Technical change to straight M12 cord sets with LED function

Please pass on this Product Change Notification (PCN) to your employees and, if applicable, to your customers.

Old wiring diagram	New wiring diagram

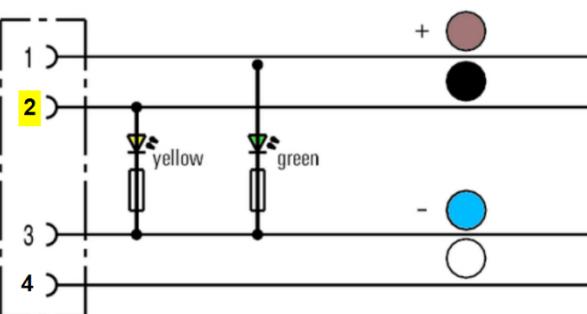
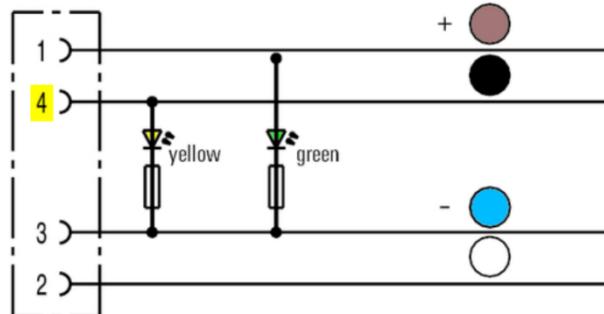
Faulty assembly of the LED on the inflowing printed circuit board

With the previous assembly, the yellow LED lights up when there is a voltage supply between pin 2 and pin 3. According to the specification, however, the yellow LED should light up when there is a signal on pin 4.

For completeness: at the 3-pole versions the **white** wire is missing (pin 2 of new wiring is not connected).

The assembly of the printed circuit board is changed so that the yellow LED lights up when there is a signal from pin 4.
